RED TEXT INDICATES CHANGES TO EXISTING OR INSTALLATION OF NEW MATERIALS IN THE VESSEL

CANADIAN COAST GUARD
VAKTA REFIT

APPROVED BY	STATUS	SHEET#	SYSTEMS
GG	FOR CONSTRUCTION	1 OF 2	1178-2 HVAC SYSTEMS
REV2

MAIN DECK PLAN

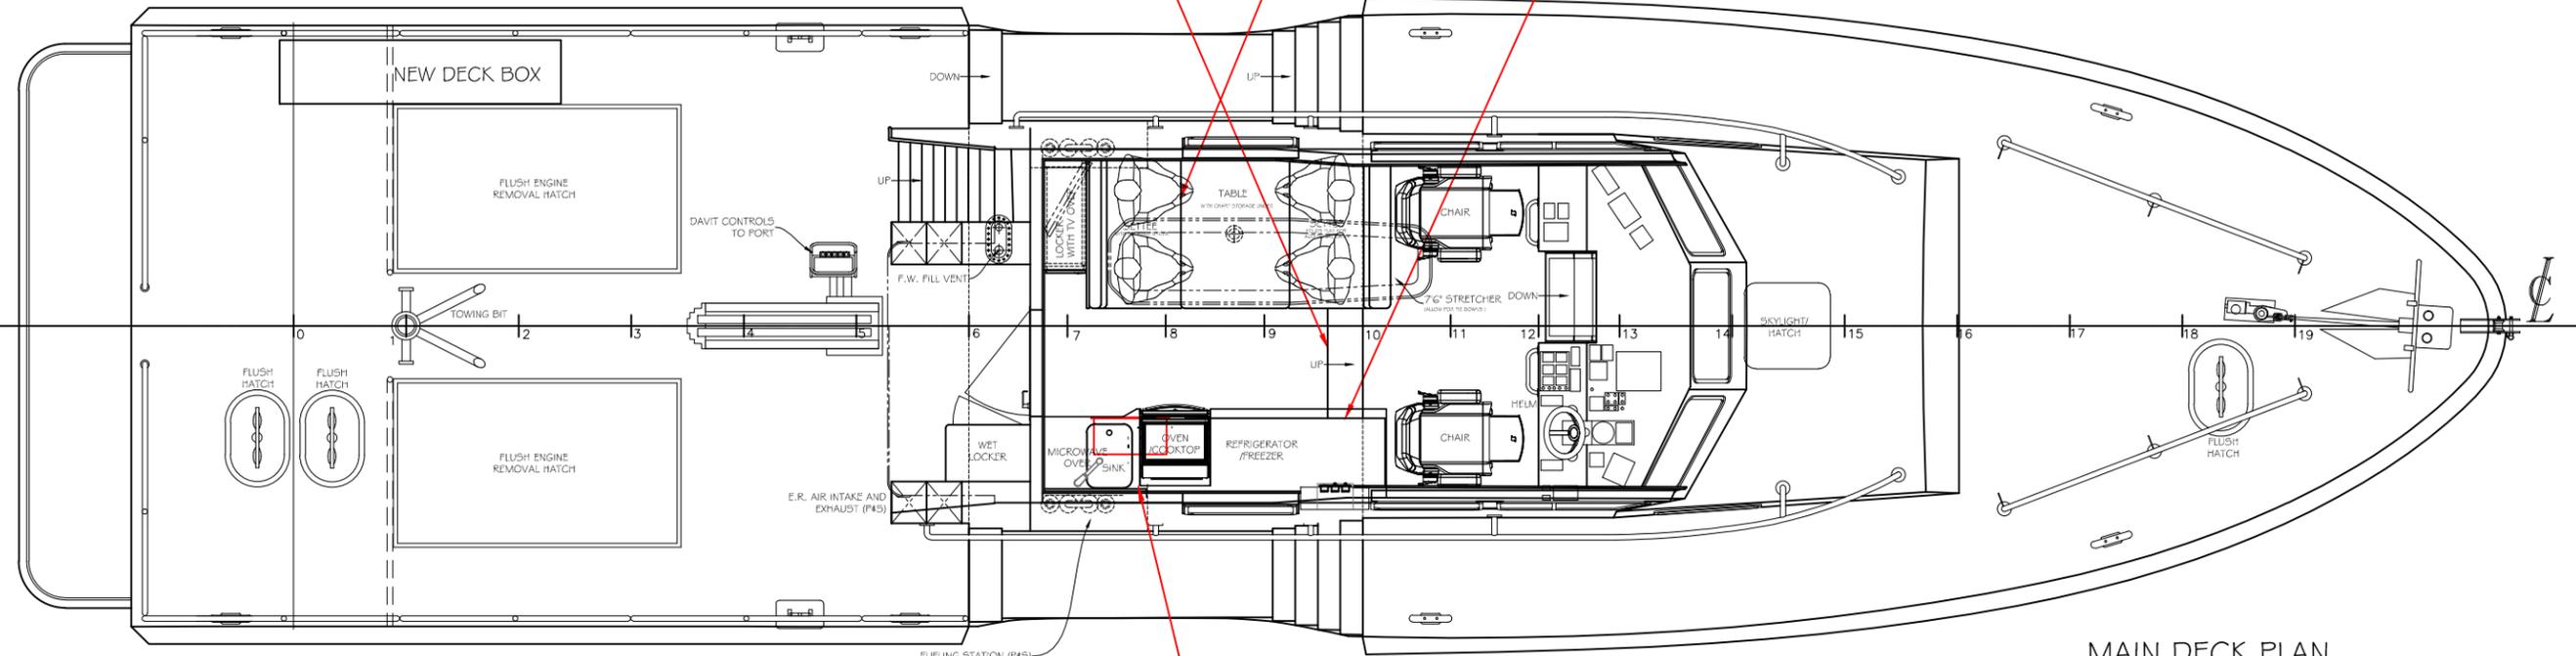
RETURN AIR GRILLES INTEGRATED INTO STEPS
MINIMUM FLOW AREA FOR COMBINED RETURN AIR VENTS TO BE AT LEAST 0.15 SQUARE METERS

RETURN AIR ON SETTEE OUTBOARD AFT SECTION POSSIBLE

AC DUCT #1 SUPPLY AIR - NEW LOCATION
GRILLE INTEGRATED INTO STARBOARD CUPBOARDS

EXTRACTION DUCT BEHIND MICROWAVE
6 INCH DUCT WITH EBM PAPST 7114N FAN
WITH A VARIABLE SPEED CONTROL
DUCT OUTLET IN DECKHOUSE SIDE PLATE TO HAVE OUTLET DAMPER

HULL DECK PLAN

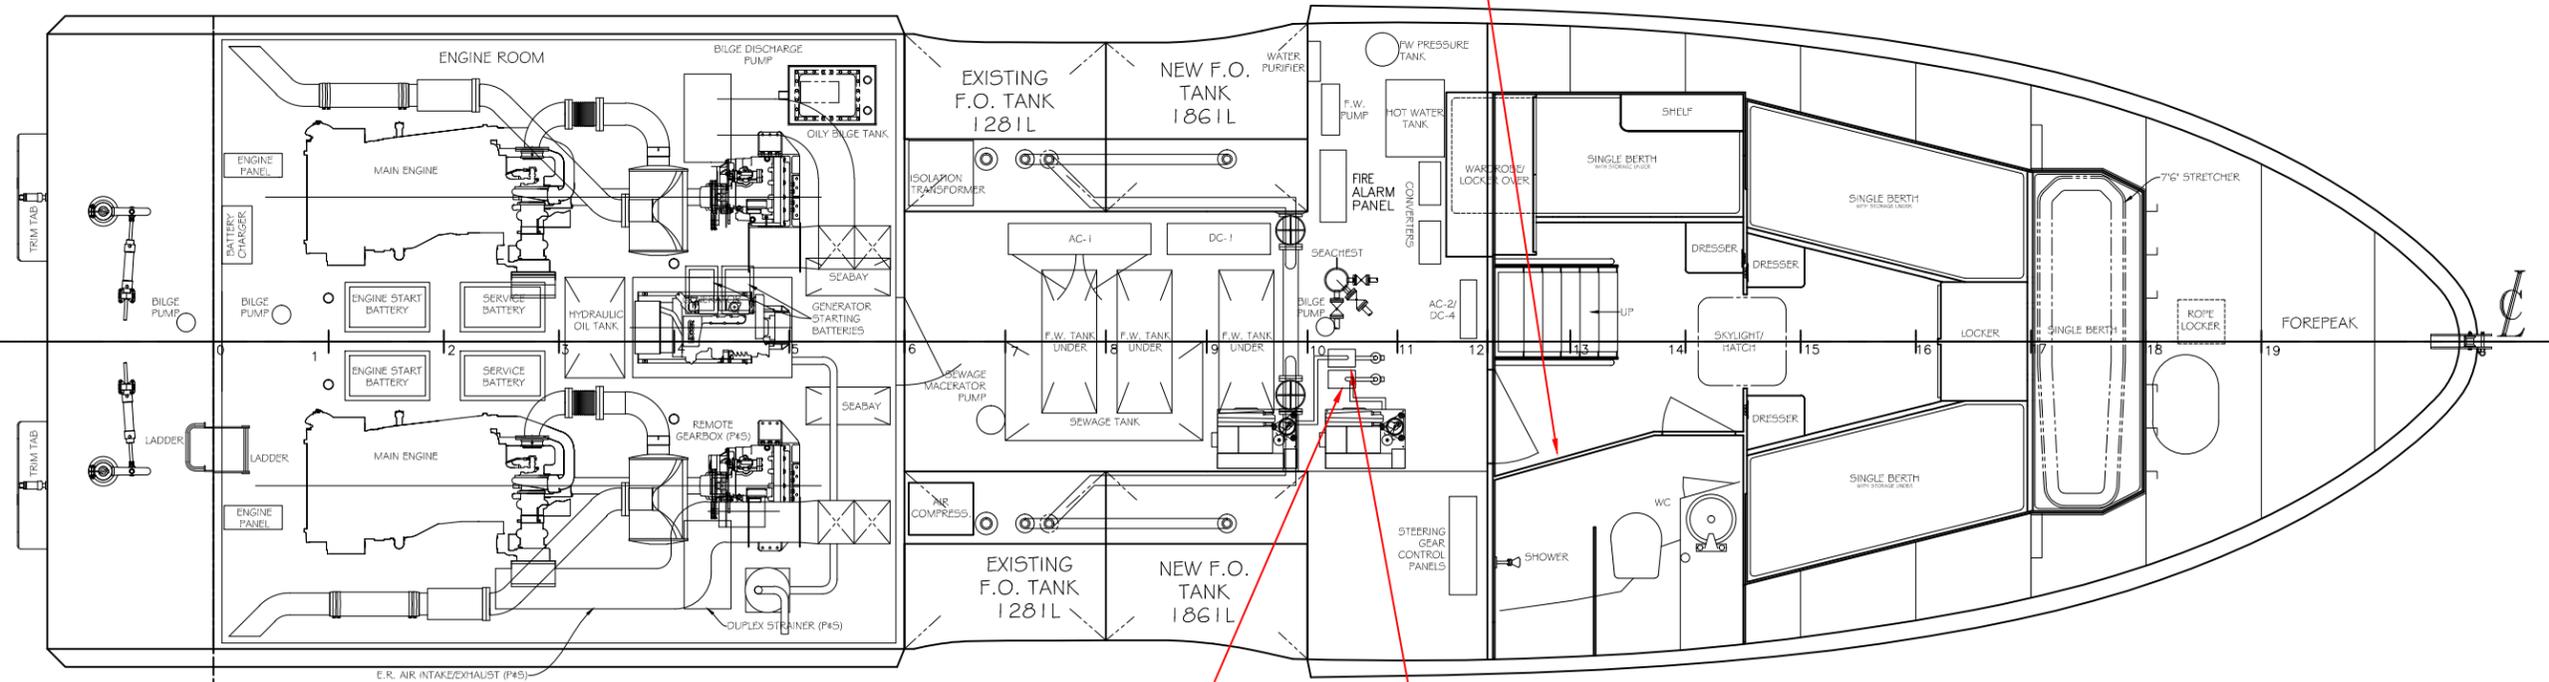
NEW LOCATION FOR AIR CONDITIONING ACCOMIDATION THERMOSTAT

RELOCATE EXISTING MARCH PUMP LC-3CP-MD PUMPS HERE
EXISTING SEACHEST AND VALVES TO BE REUSED IF CONDITION PERMITS

ADD REMOVABLE DECK PLATE FOR ACCESS TO THRU HULL FITTINGS AND PUMPS
